# Changes to XLAUI/CAUI Electrical Specifications

Cisco Systems

October 2008

Figure 153A-2—Definition of transmit and receive test points

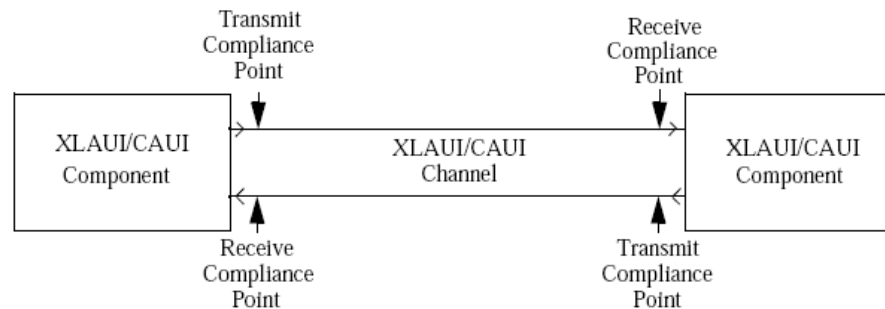
153A.3.3 Transmitter characteristics, applies at TP0 and TP4 (eqv. to XFI A,C resp.).

153A.3.4 Receiver characteristics, applies at TP1 and TP5 (eqv. To XFI B,D resp.).

TP1,TP4 (XFI B,C) are at or near module connector pins.  
TP0,TP5 (XFI A,D) are at or near host ASIC pins.

This is not clear from Figure 153A-2.

# Test Point (TP0,TP5) Definition

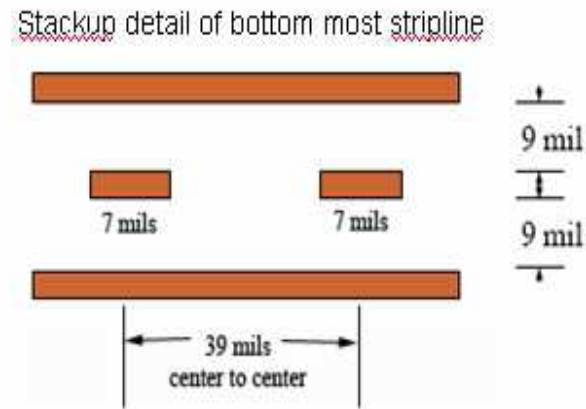
Since ASIC/serdes pin/balls are associated with complex EM fields (non-TEM), it may be better to define TP0 and TP5 on a test board as the cross-section of two uncoupled stripline traces, 1" away from the component.

Alternately, TP0 and TP5 can be defined to be at the test board connector, with the test board defined to have a loss of 0.5 +/- 0.1dB at  $F_{\text{baud}}/2$  (Ali Ghiasi's suggestion).
